STAFF REPORT: NOVEMBER 13, 2024 MEETING
APPLICATION NUMBER: HDC2024-00619
ADDRESS: 1639 LEVERETTE

HISTORIC DISTRICT: CORKTOWN
APPLICANT: TIMOTHY ANDREW BRODOWSKI, CONSTRUCTION BY DESIGN, LLC.
PROPERTY OWNER: ANDRUS MCDONALD
DATE OF PROVISIONALLY COMPLETE APPLICATION: OCTOBER 21, 2024
DATE OF STAFF SITE VISIT: NOVEMBER 1, 2024

SCOPE: REPLACE AWNING WINDOW WITH EGRESS CASEMENT UNIT

Existing conditions. Staff photo, November 1, 2024. Location of window.

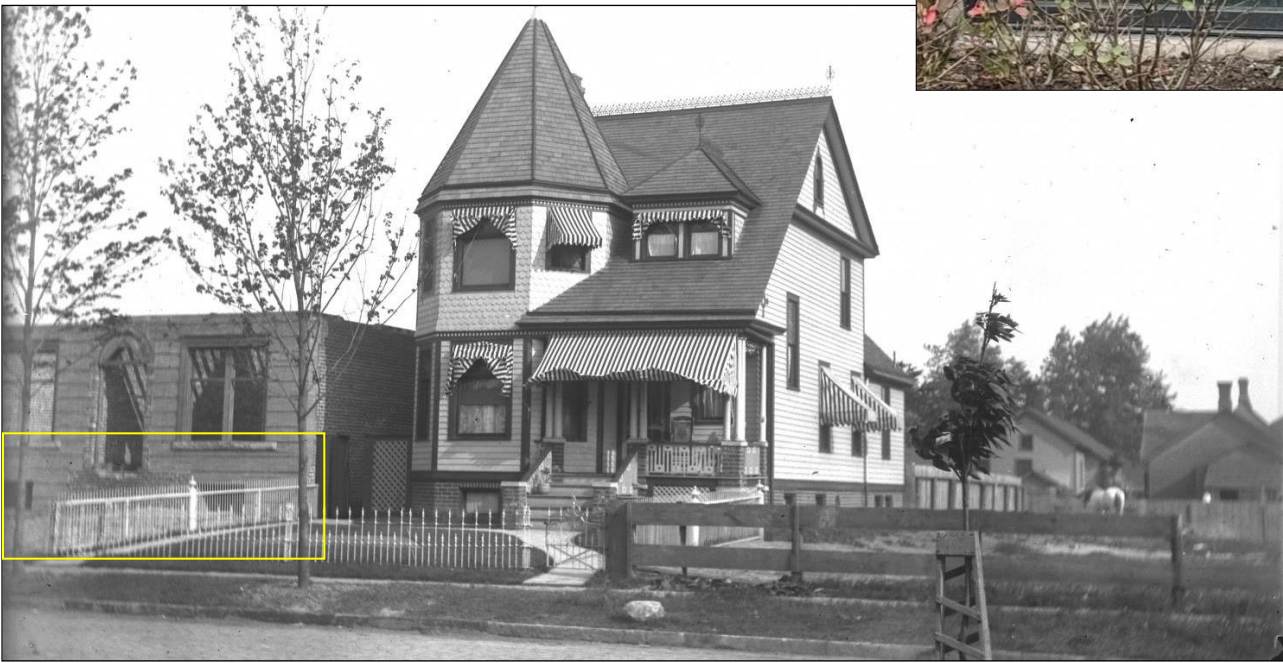
- The location of the window is to the immediate right of the townhouse’s entrance. It is staff’s opinion the basement windows are minimal, utilitarian features on the façade. They are only visible when viewing the building straight on, unlike the detailed openings and features at the first and second floors and roofline. Additionally, the basement openings have concrete surrounds, which is a sharp contrast to the opulent details of the dominant features of the façade.
- The applicant states the need for the egress window is so a lower level bedroom can be constructed, and that the location of the interior stairs to the first floor precludes the possibility of locating the bedroom near the back of the building.

Above: This photo from the Burton Collection, dated 1895, shows the western end of the townhouse building in its early stage of construction.

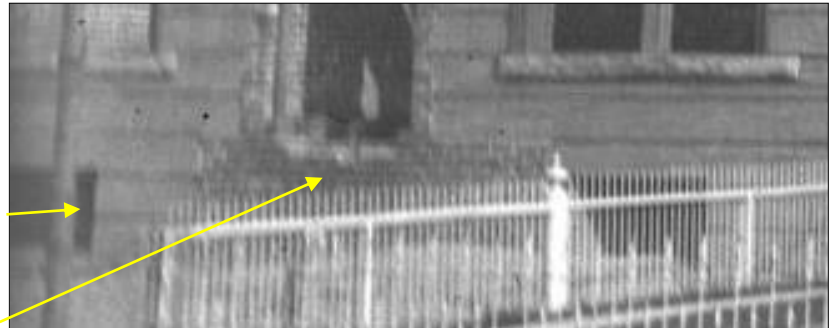
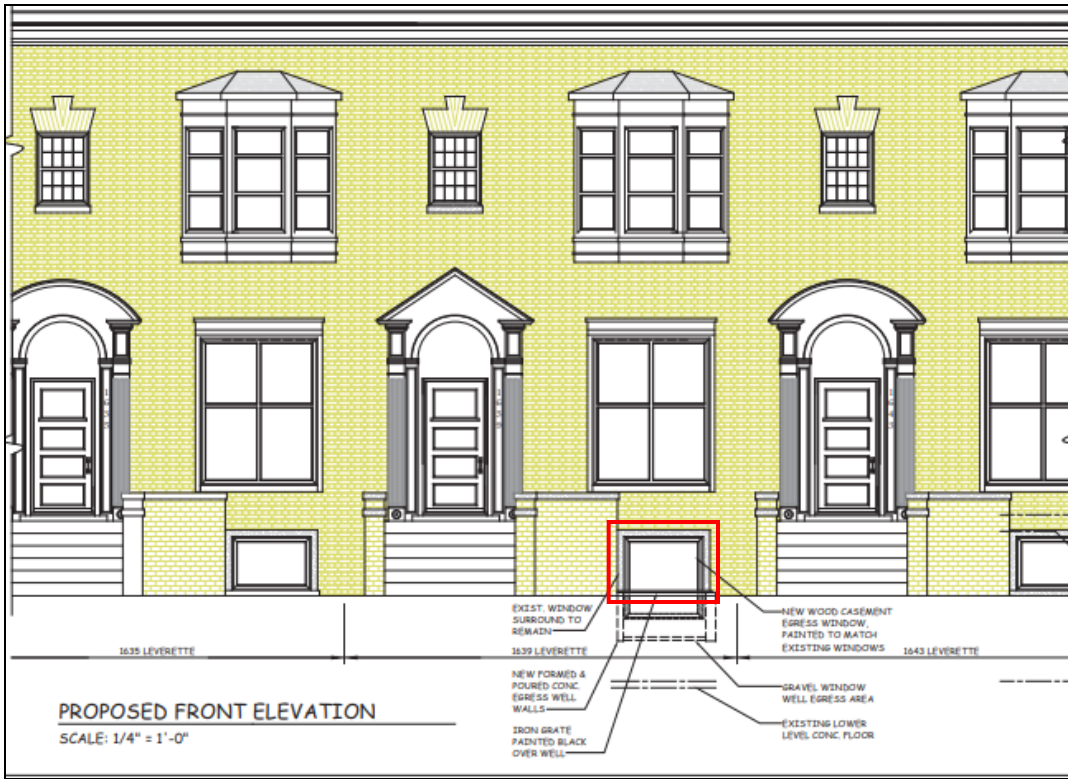
Right: The enlarged portion of the above photo is a bit grainy, however it appears to staff that the basement window openings originally did not have casings, which is very common for openings in masonry-clad structures. You can also see, by the use of common brick, the planned placement of the entry porches.

Applicant drawing

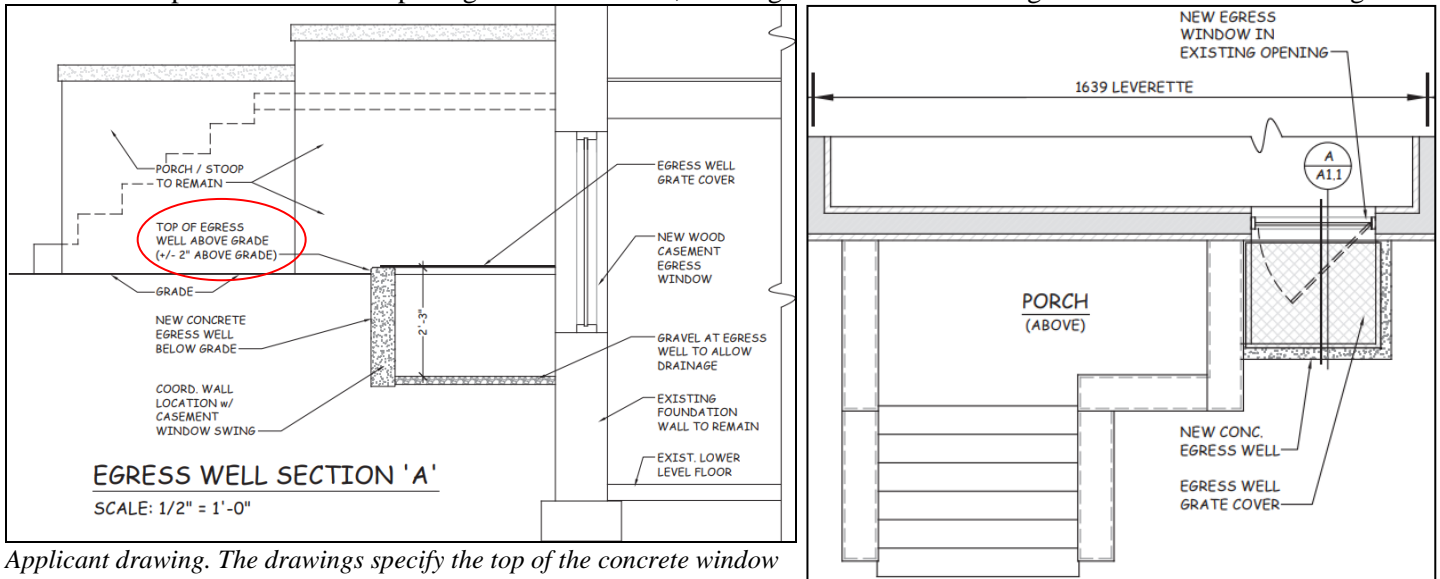
- This applicant's elevation drawing shows the proposed window opening will retain the width and height of the existing opening; the additional height of the egress window will be below grade. The existing window surround at the top and sides of the opening will also remain, offering minimal visual change to the wall of the building.

Applicant drawing. The drawings specify the top of the concrete window well walls will not exceed two inches above grade.
